APPLICATION FOR PERCOLATION TEST

SITE DISAPPROVAL REPORT
INDIVIDUAL SEPTIC TANK SYSTEM WITH SUBSURFACE, SOIL ABSORPTION, EFFLUENT DISCHARGE

LOCATION OF LOT 8821 Liberty Hill Drive, Lot 4-D

7) ACCURATELY DIAGRAM & DIMENSION LOT

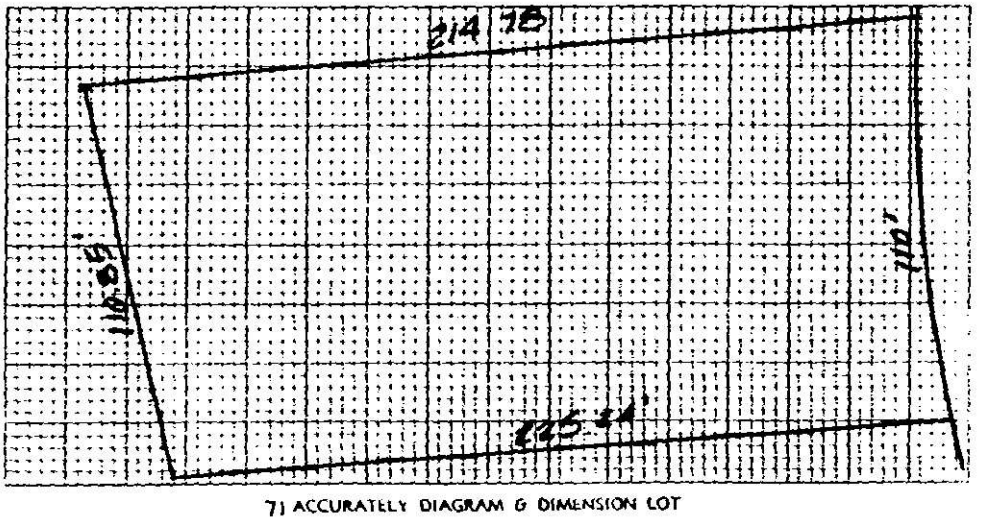
X ON SITE INSPECTION REVEALED LOT TO BE UNSUITABLE FOR THE FOLLOWING REASON(S) Soils were found to be imperfectly drained alluvial soils. These soils have a seasonal high water table which results in inadequately slow percolation rate and permeability.
